Noyac Bay

SUITE 211
ORIGINAL LAYOUT
INVENTORY SUITE

*** SUITE 211 * (INVENTORY SUITE)**
NEW PLAN
-REMOVED DEN
-REVISED KITCHEN
*REVISED LAUNDRY DOOR SWING &
ENSUITE WALL AS PER THIS BROCHURE

CLIENT: ROYAL PINE HOMES

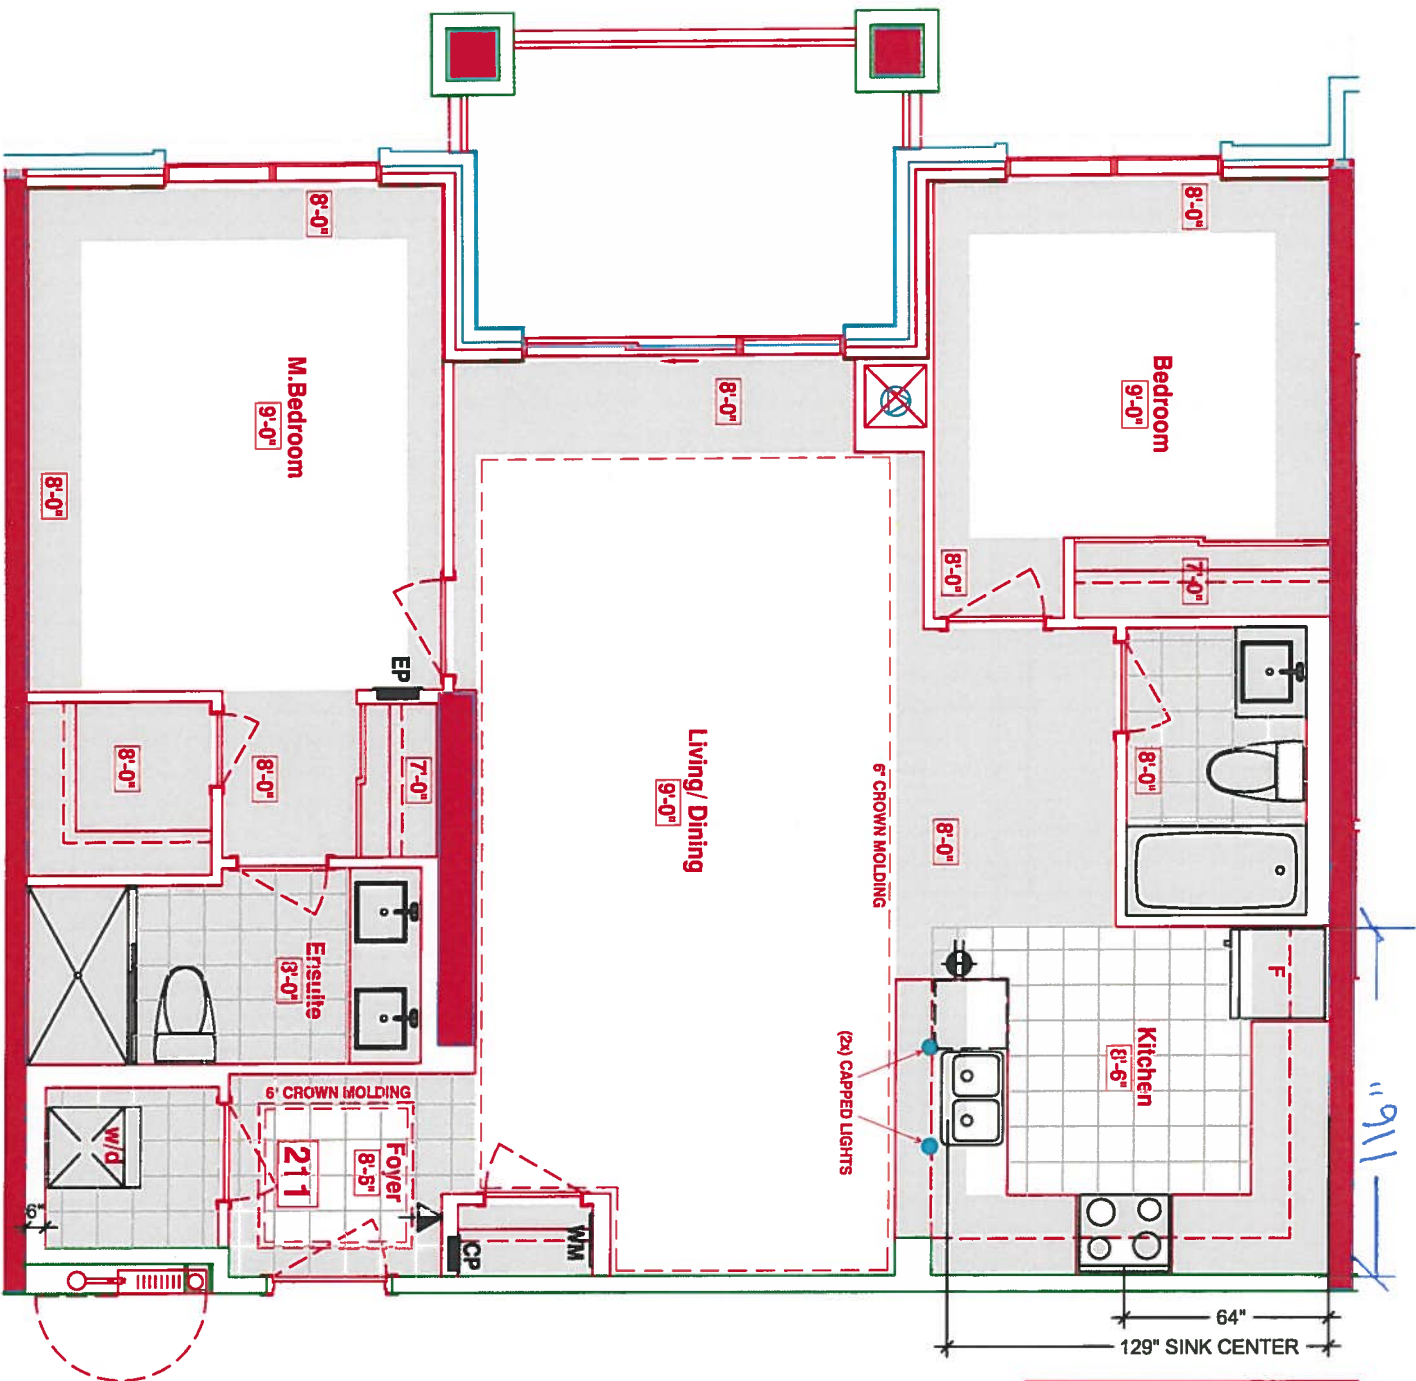
*** KITCHEN ***
CHOICE OF STD. KITCHEN LAYOUT WITH
STD. APPLIANCE PACKAGE
OR
CAN UPGRADE AT DECOR CENTER
- (x2) CAPPED PENDANT
- (x1) PLUG PENINSULA
- (x) PUCK LIGHTS
*SEE ATTACHED UPG.
#1- KITCHEN LAYOUT WITH 1ST UPG.
APPLIANCE PACKAGE
